AIRCRAFT AND MAINTENANCE PARTS

NORTH AMERICAN—INSTALLATION OF COTTER PIN IN MAIN LANDING-GEAR
OPERATING STRUT END FITTING—P-51D, P-51K, AND F-6 SERIES

This Technical Order replaces T. O. No. 01-60-102, dated 30 June 1948, revised to delete obsolete models and change effective point of P-51D aircraft.

Figure 1 - Rework of Landing-gear Retract Strut

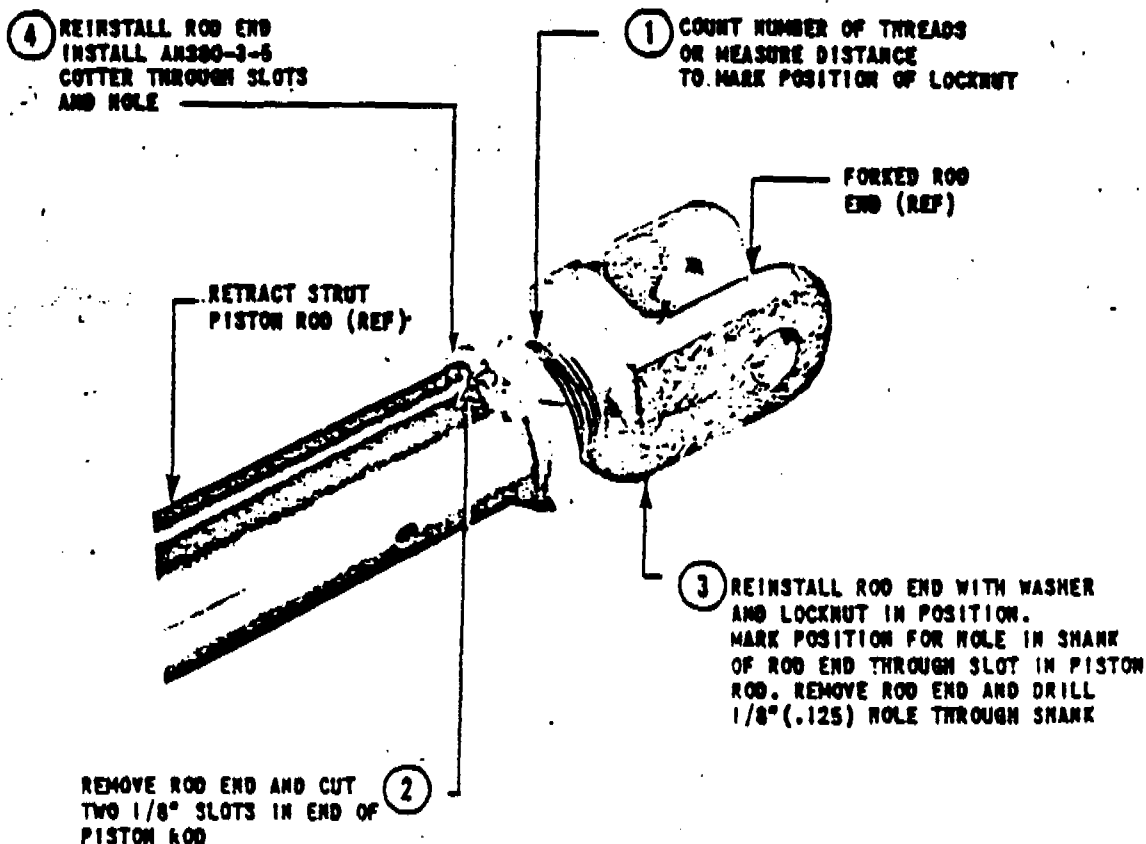
1. To minimize failure of the main landing-gear operating strut and connecting linkage which results when the piston assembly turns on the strut end fitting,

a cotter pin will be installed through the end fitting and piston assembly in accordance with the instructions contained in paragraph 2.

a. (See figure 1.) Locate the piston rod in the retract strut in the aft portion of the wheel well.

c. (See figure 1.) Cut two 1/8-inch square slots, one opposite the other in the outboard end of the piston rod. Clean out all metal chips and filings.

b. Disconnect the linkage from the forked rod end and loosen the lock nut on the shank of the rod end. Remove the rod end from the piston rod of the strut. When removing rod end count the number of threads or measure the distance between the lock nut and the rod end shoulder.

d. Reinstall the forked rod end with washer (if installed) and lock nut. Make certain lock nut is in same position on shank as before removal. Screw the rod end into the piston rod until lock nut and washer are firmly against the end of the piston rod.

e. Through one of the slots just cut, mark the position for the hole on the threaded shank of the rod end. Use a scribe or other sharp instrument.

f. Remove the forked rod end and drill a 1/8-inch (.125-inch diameter) hole through the shank at the point marked.

g. Discard the washer (if originally installed) and reinstall the rod end in the piston rod. Screw the rod end in until the hole lines up with the slots cut in the piston rod. Install one cotter pin, part No. AN380-3-8.

h. Tighten the lock nut against the piston rod and reconnect the gear linkage to the rod end.
